# HISTORIC AND DESIGN REVIEW COMMISSION

June 21, 2017

**HDRC CASE NO:** 2017-284  
**COMMON NAME:** 127 E GRAYSON  
**ADDRESS:** 131 E GRAYSON ST  
**LEGAL DESCRIPTION:** NCB 974 BLK 17 LOT 13 & 14  
**ZONING:** C-3NA, RIO -2  
**CITY COUNCIL DIST.:** 1  
**APPLICANT:** Bobby Eicholz/Rialto Studio  
**OWNER:** Gene Bartosh/Rio Perla Properties, LP  
**TYPE OF WORK:** Construction of surface parking  
**REQUEST:**

The applicant is requesting a Certificate of Appropriateness for approval to construct a temporary surface parking lot to accommodate parking for forty automobiles.

## Layout Plan

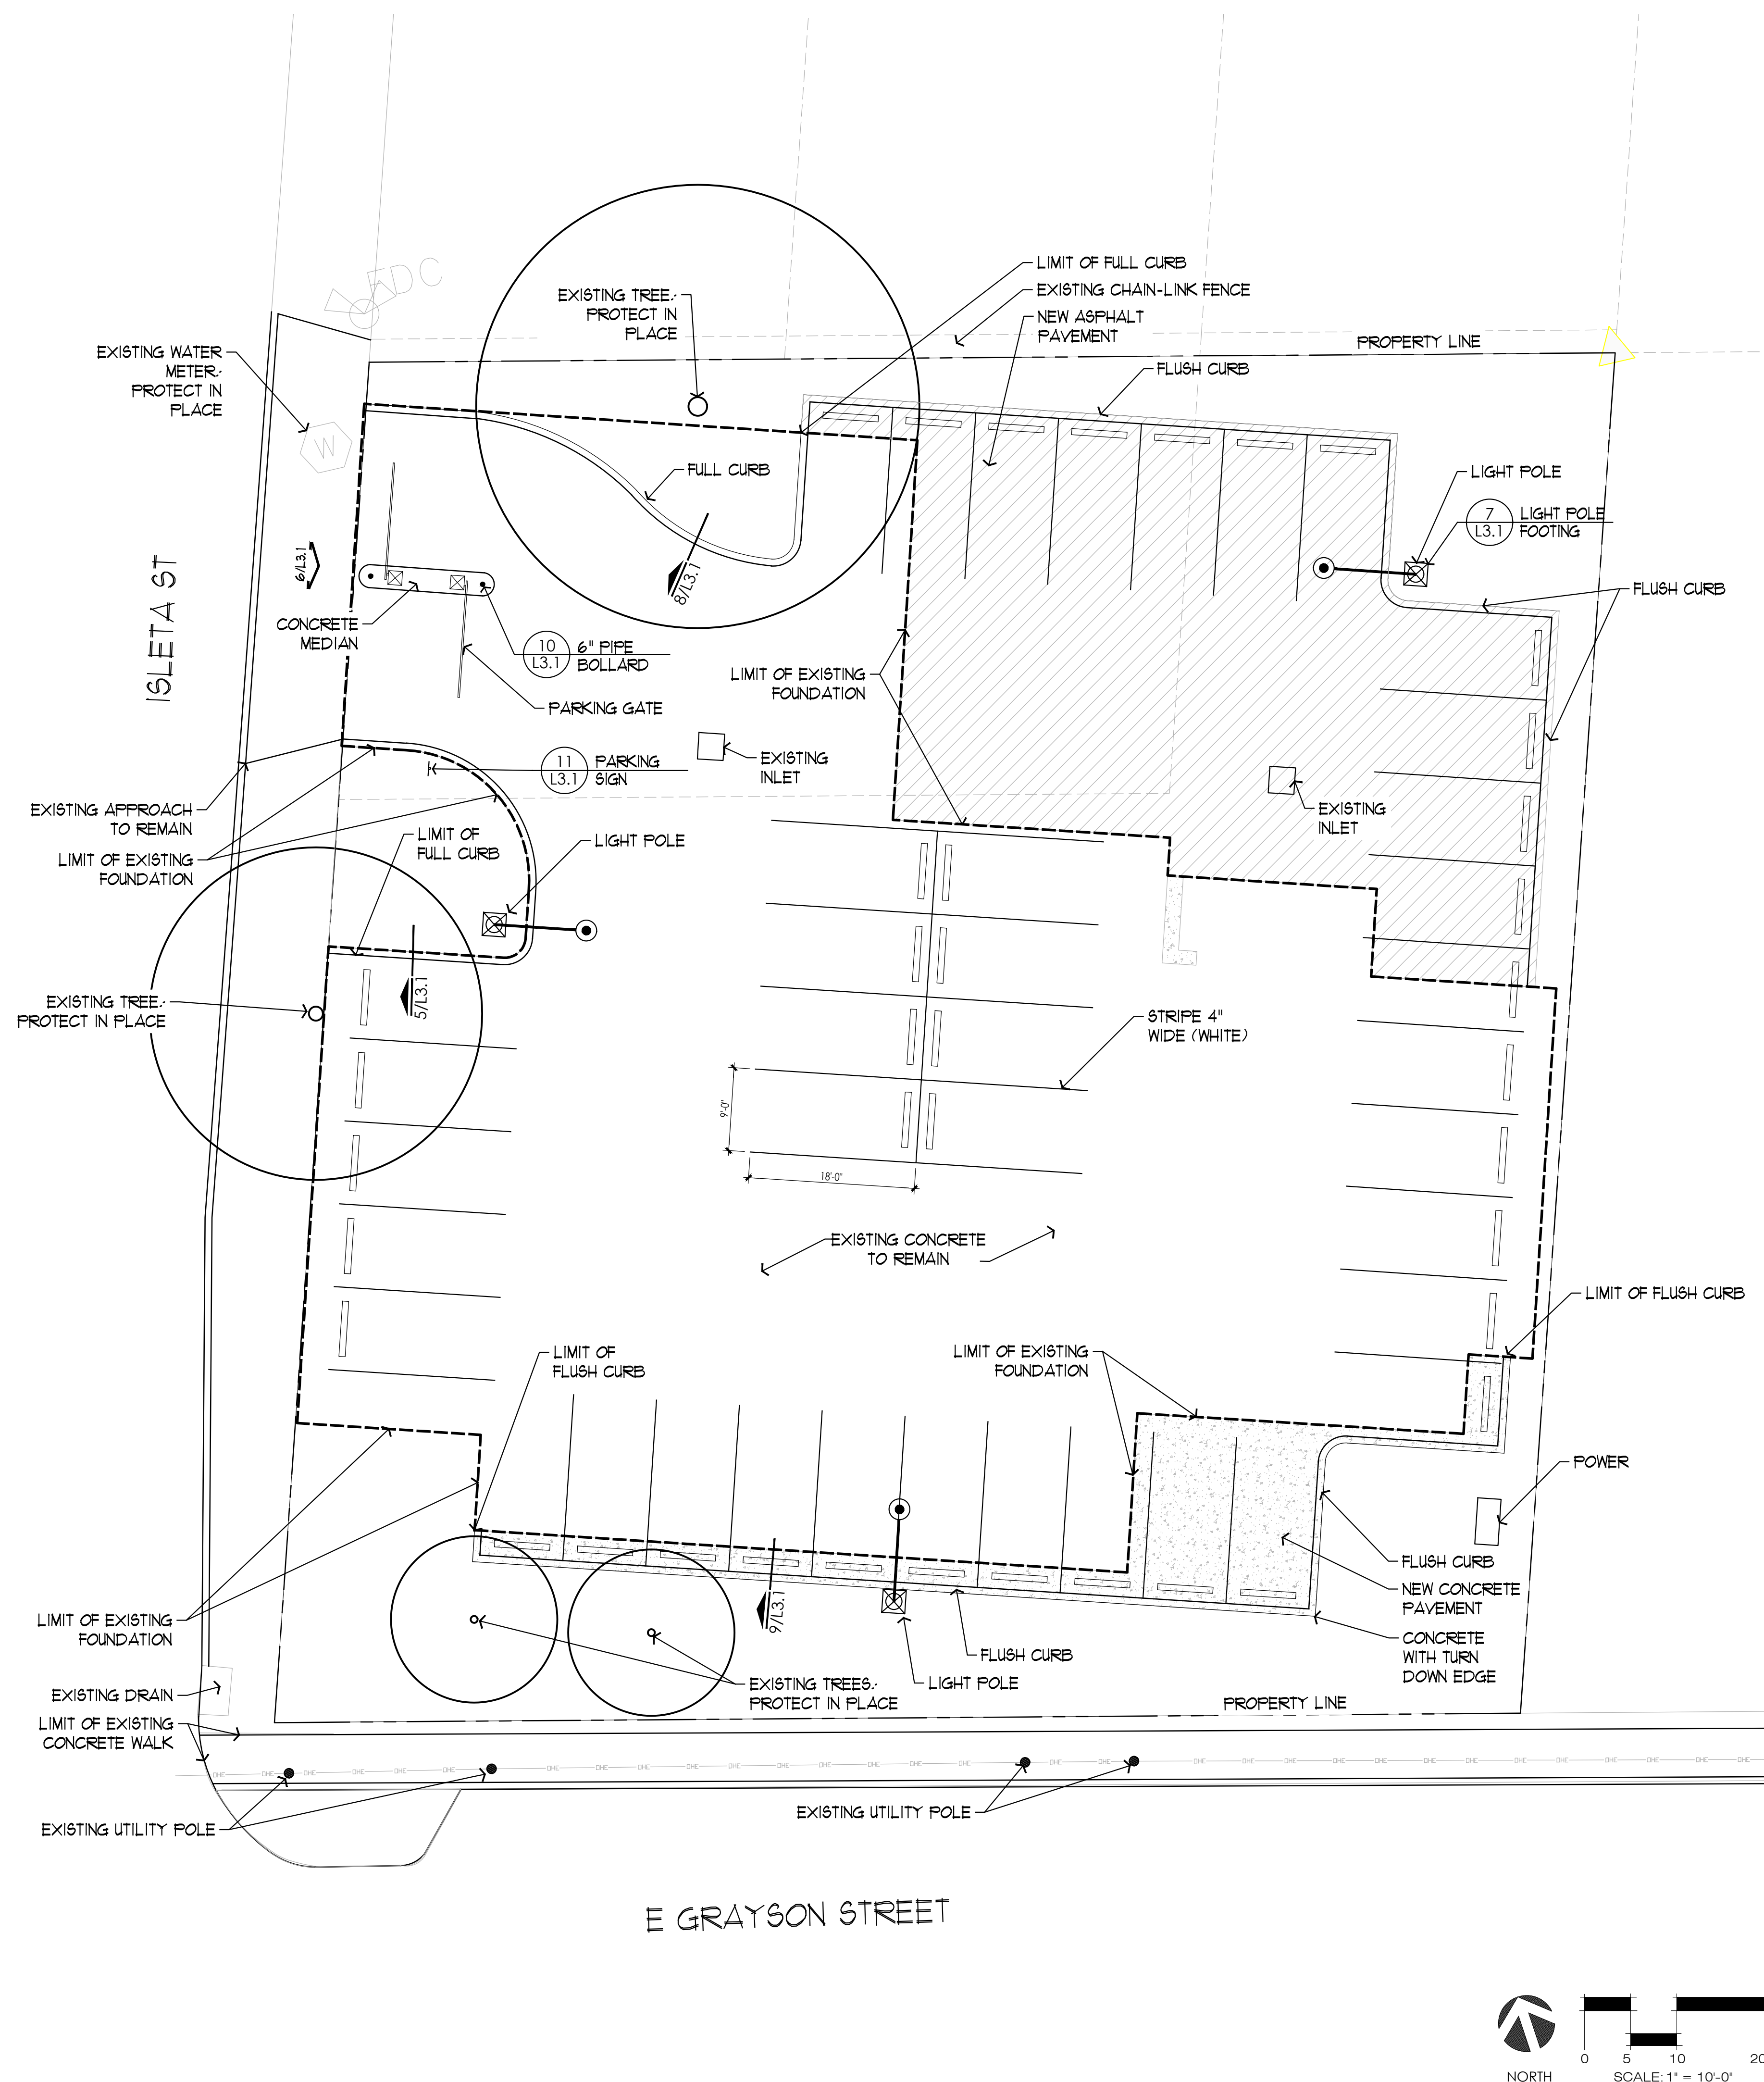
- a. The applicant has proposed to construct a surface parking lot at 127 E Grayson, at the corner of E Grayson Street and Isleta Street. Within this request, the applicant has proposed to utilize the existing concrete slab. The proposed parking lot will accommodate forty (40) automobiles. The applicant has proposed to utilize an existing curb cut for automobile entry to the lot, which is located on Isleta Street.

- c. PARKING LOT – As noted in finding a, the applicant has proposed to utilize the existing concrete slab and curb cuts for the proposed new parking. The northwestern portion and a small southwestern portion of the site currently does not feature a slab and the applicant has proposed to install new asphalt paving.

Staff recommends approval as submitted based on findings a through d.

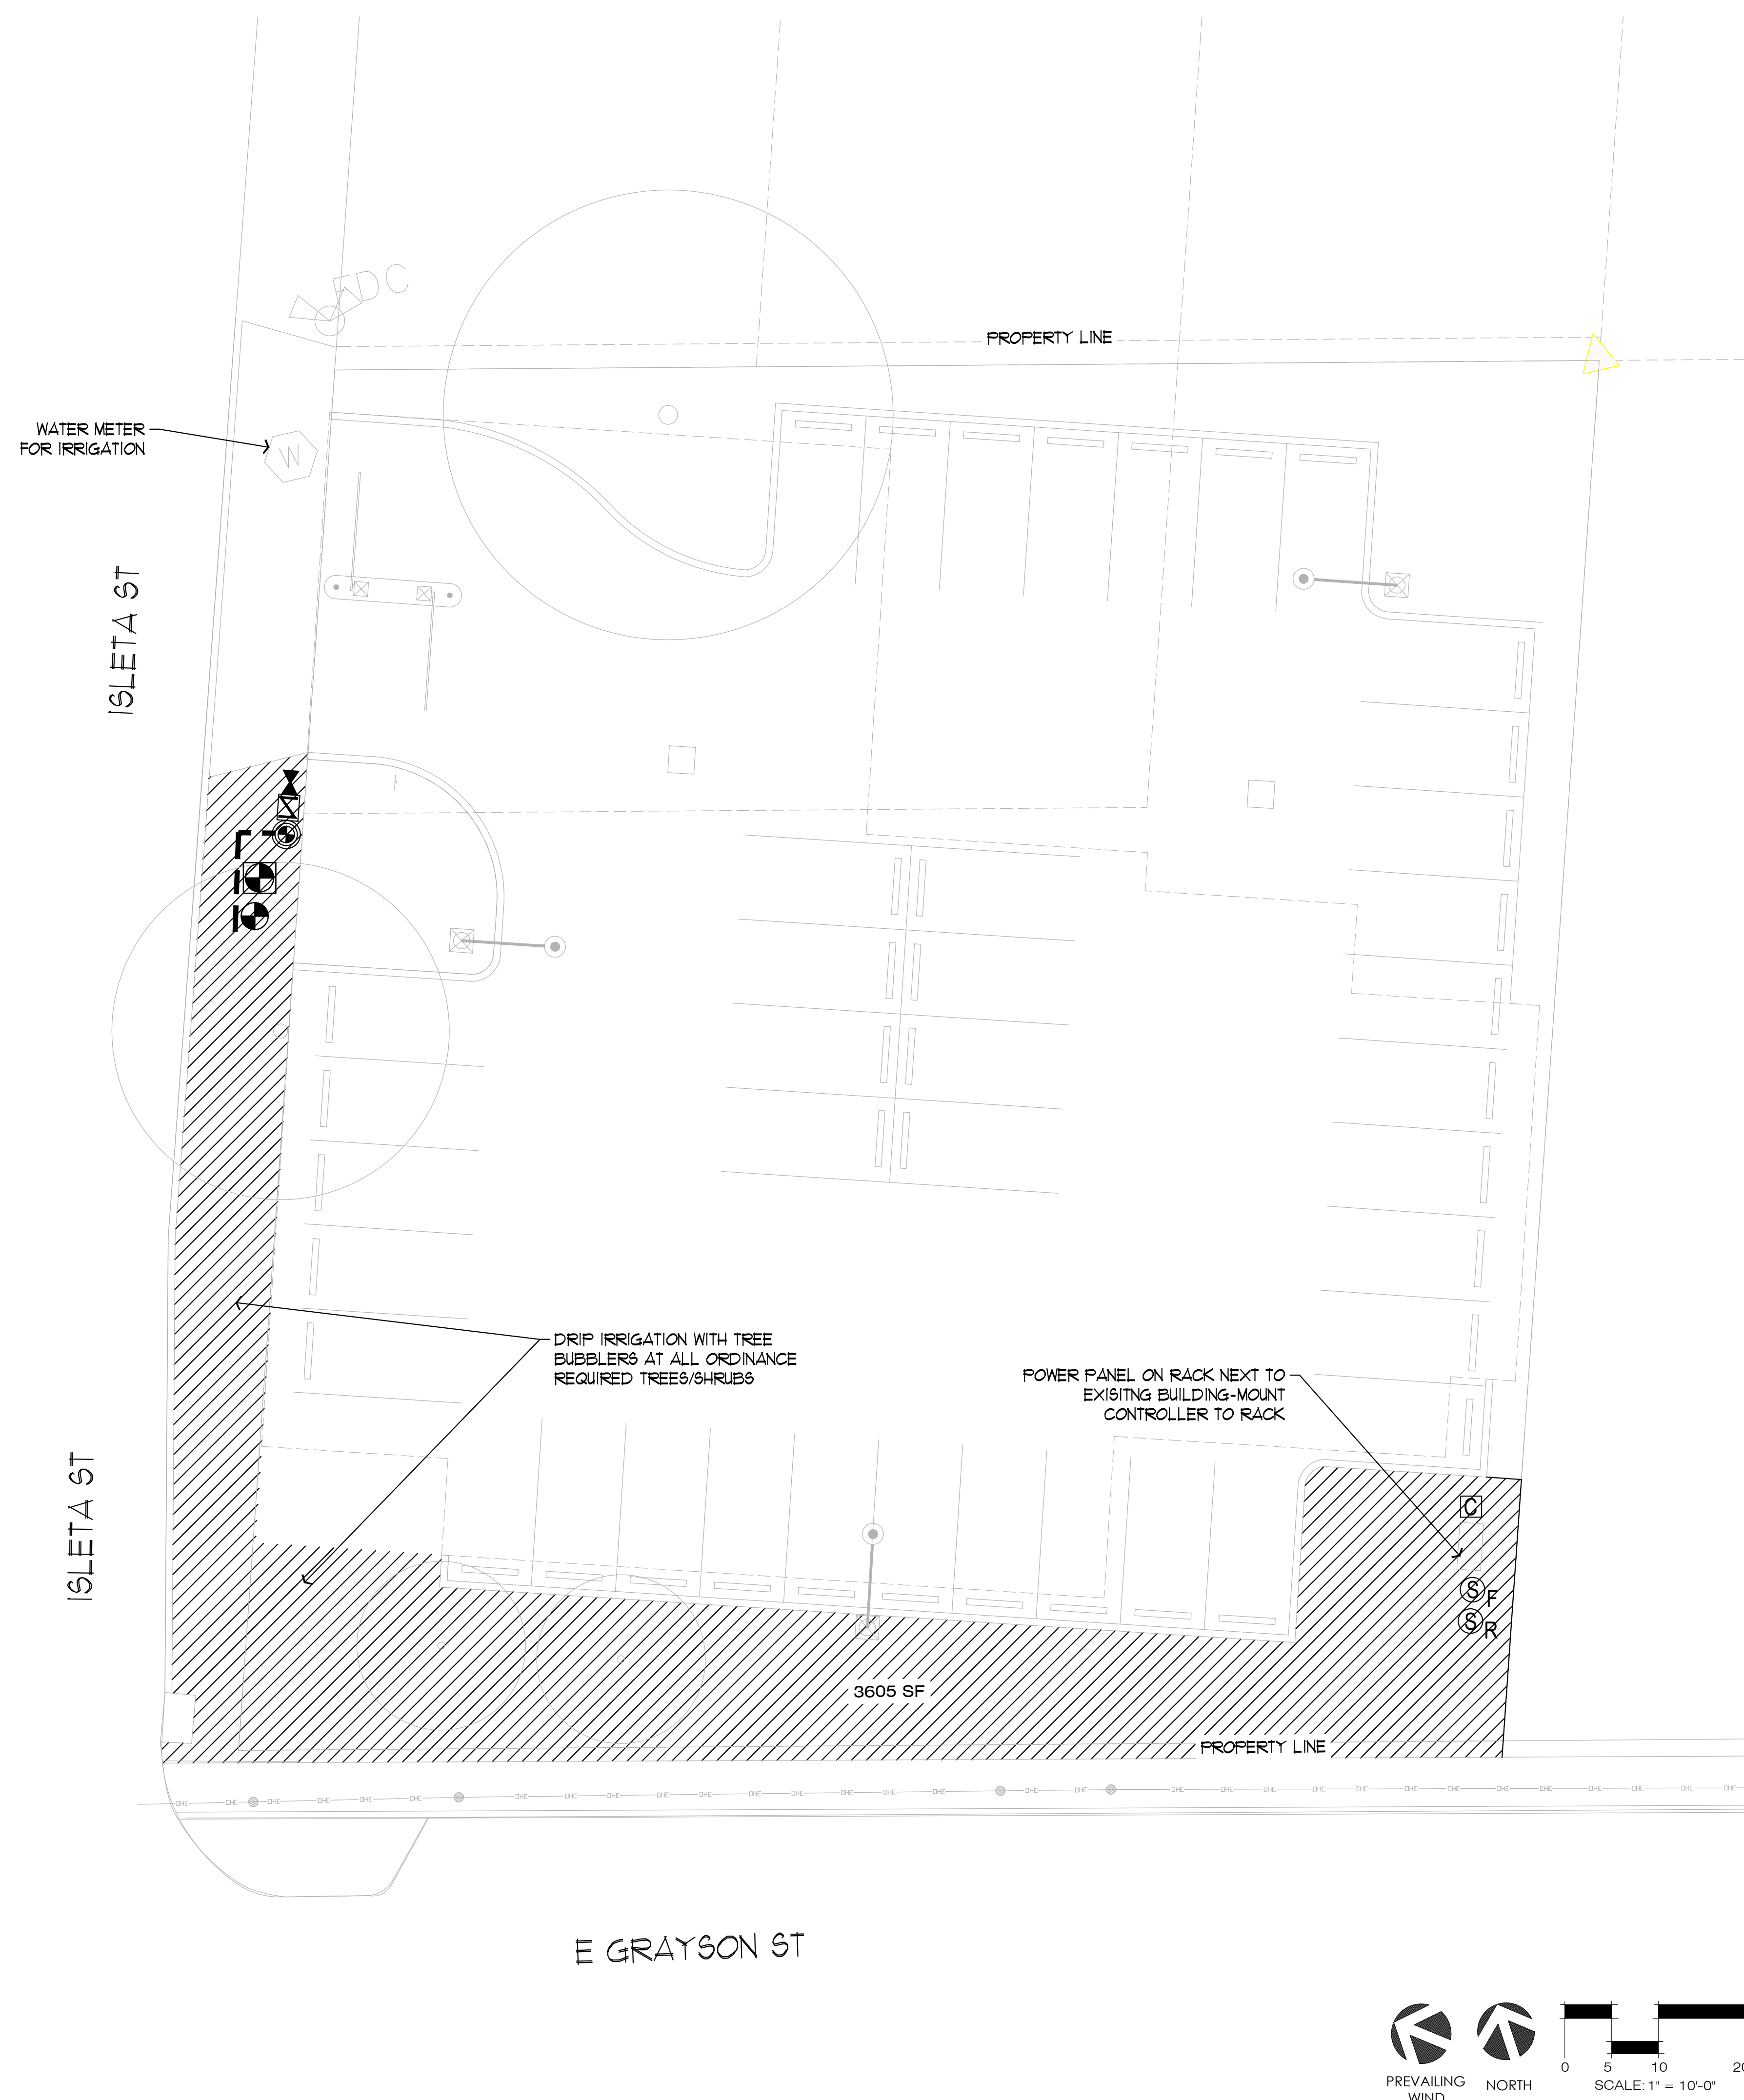
- b. LANDSCAPING – The applicant has proposed to preserve the existing site trees and has proposed to install a series of landscaping materials that are to extend in a planting garden along the public right of way along E Grayson and Isleta Streets. The applicant has proposed for the landscaping buffer to contain a series of plant materials that are both xeric and native to South Texas. This is consistent with the UDC Section 35-673.

Lighting  
Plan

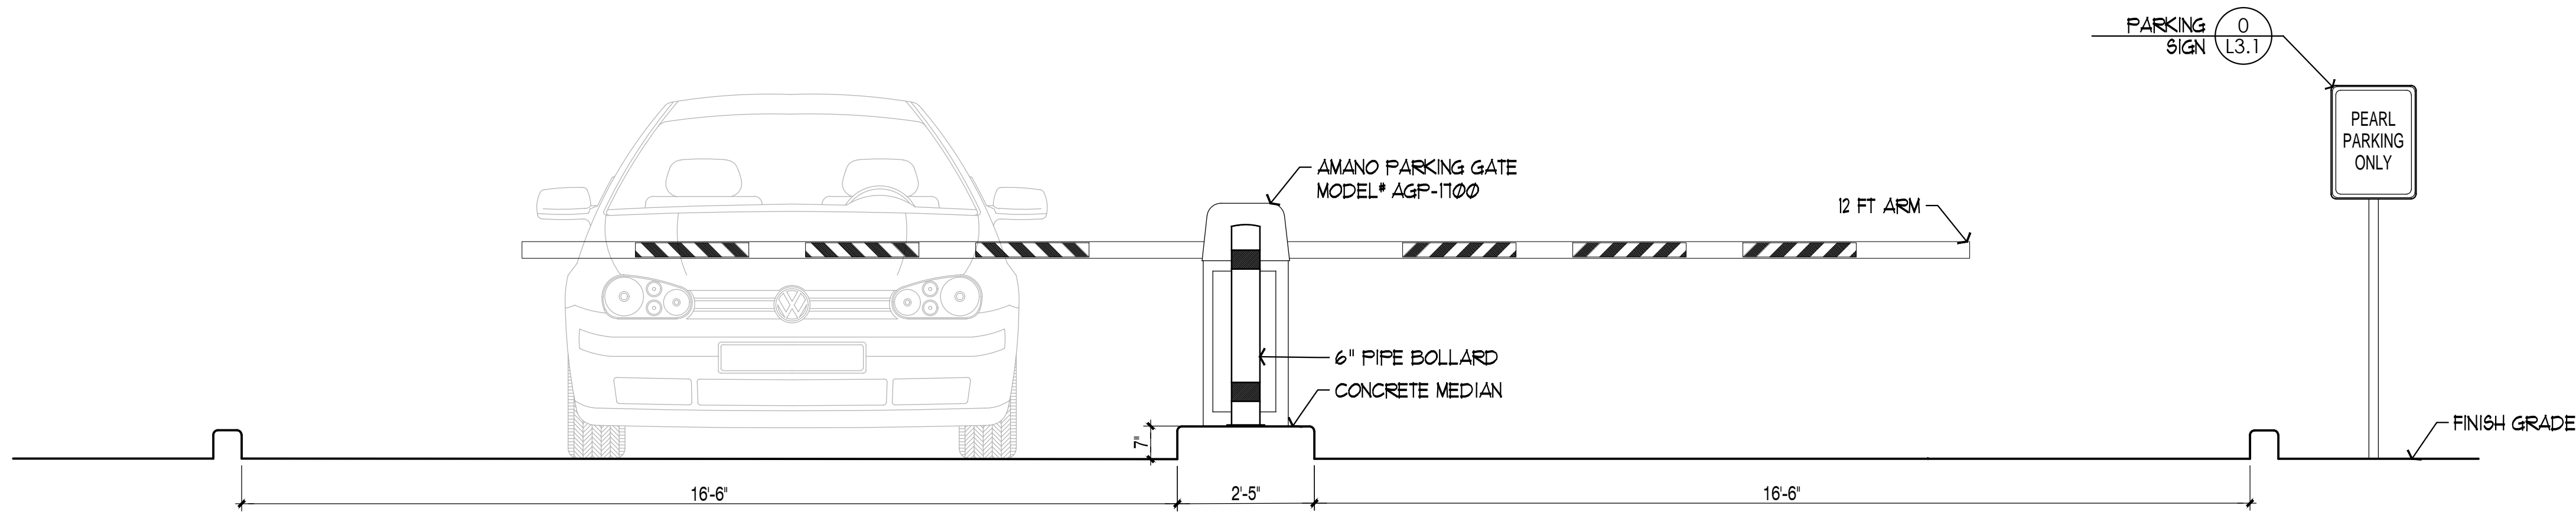
- d. SITE UTILITIES– The applicant has proposed a number of site utility items including light poles, a concrete median and parking gate and parking bumpers. Staff finds the proposed items appropriate. The applicant has noted that site lighting will be consistent with that featured at the Pearl Full Goods parking lot to the south. Staff finds this proposal appropriate. The applicant is responsible for complying with the UDC Section 35-673.
